Kirkan Onshore Wind Farm

Additional Information

Title: Kirkan Onshore Wind Farm: Additional Information

Client: Kirkan Wind Farm Ltd

TITLE: Figure 2.1 - Relocated Position of Turbine 5
Map 1 of 1

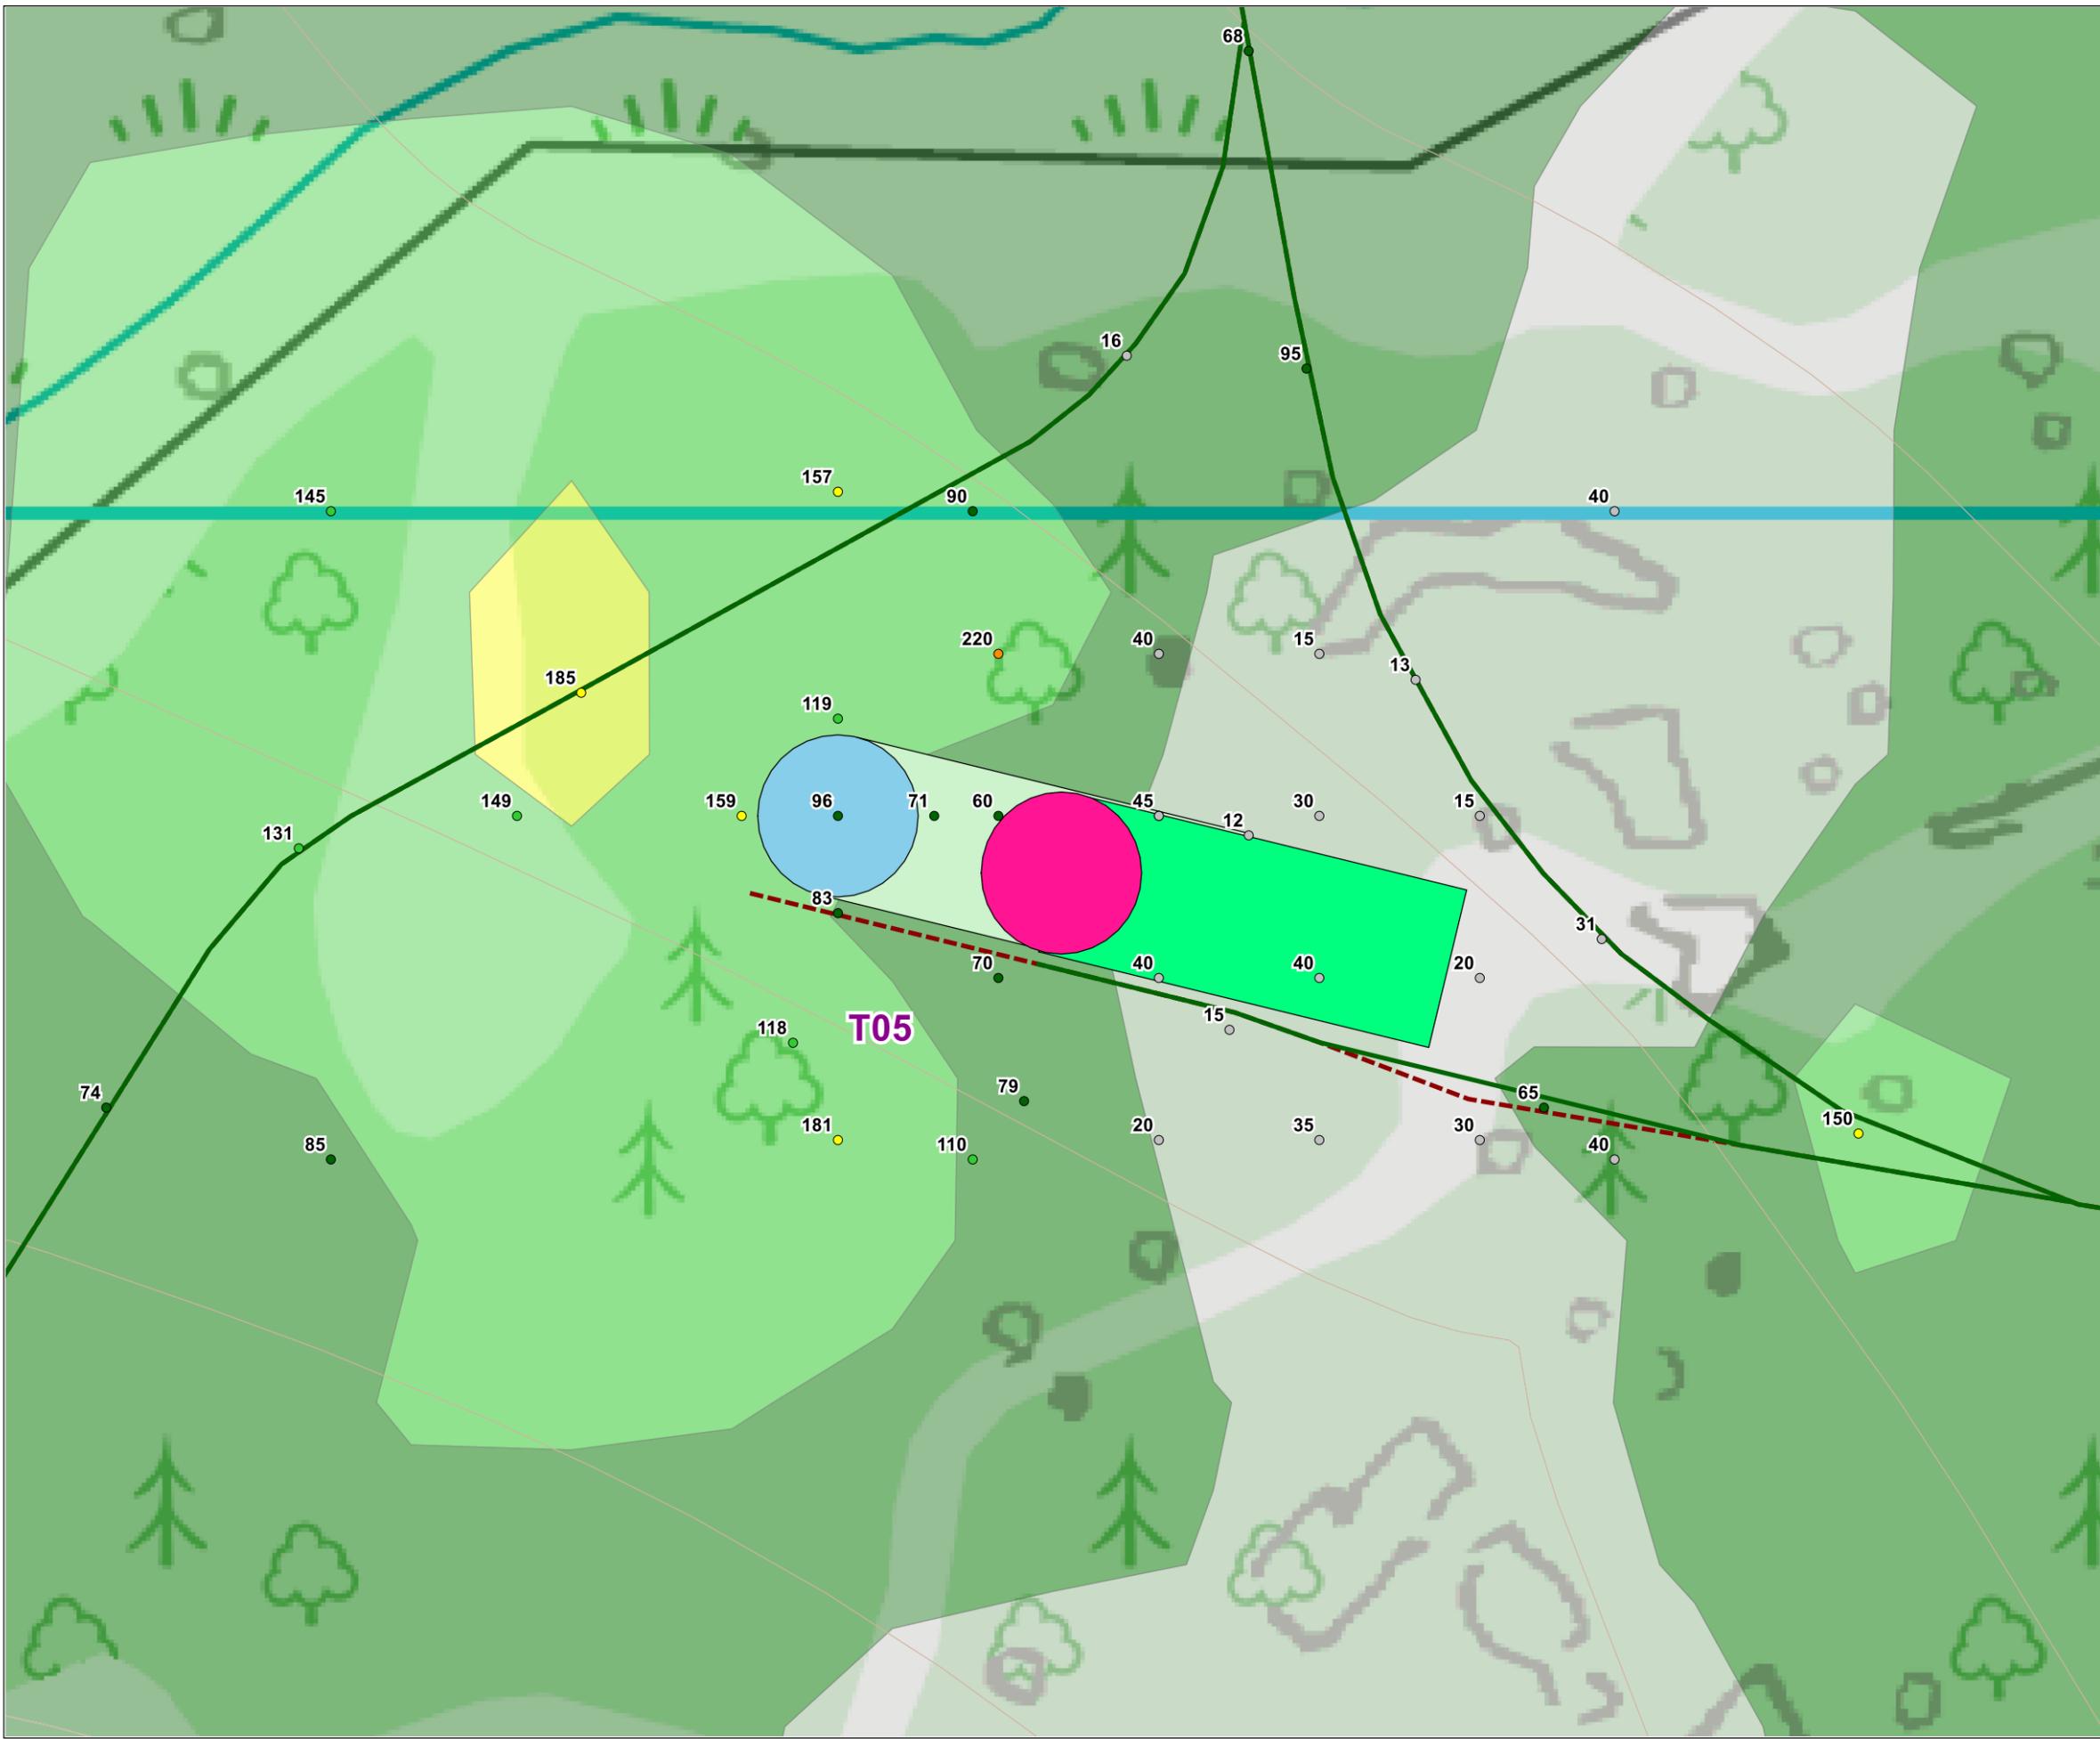
- 2.12 Track section 2 includes the revised access to Turbine 5, which is slightly shorter than the previous track link. Track section 6 includes the new access to Turbine 7, which is also slightly shorter than the previous track link.
- 2.13 Overall, reduction in excavation volumes from the access track of approximately 15% has been achieved from the original layout, with the most recent changes providing a 3.3% decrease from the SEI layout.

- 4.4 Given the very minor difference in location between the previous turbine locations and those currently proposed (with Turbine 5 having moved 35.9 m east-southeast from its former location, and Turbine 7 having moved 35.3 m north), it is not considered that there would be any such change. Indeed, it is noted that the changes are within the 50 m micrositing allowance which was already considered as part of the assessment work undertaken. It is acknowledged that a new 50 m micrositing allowance would now apply to the revised turbine locations, but again the assessments would continue to be applicable..
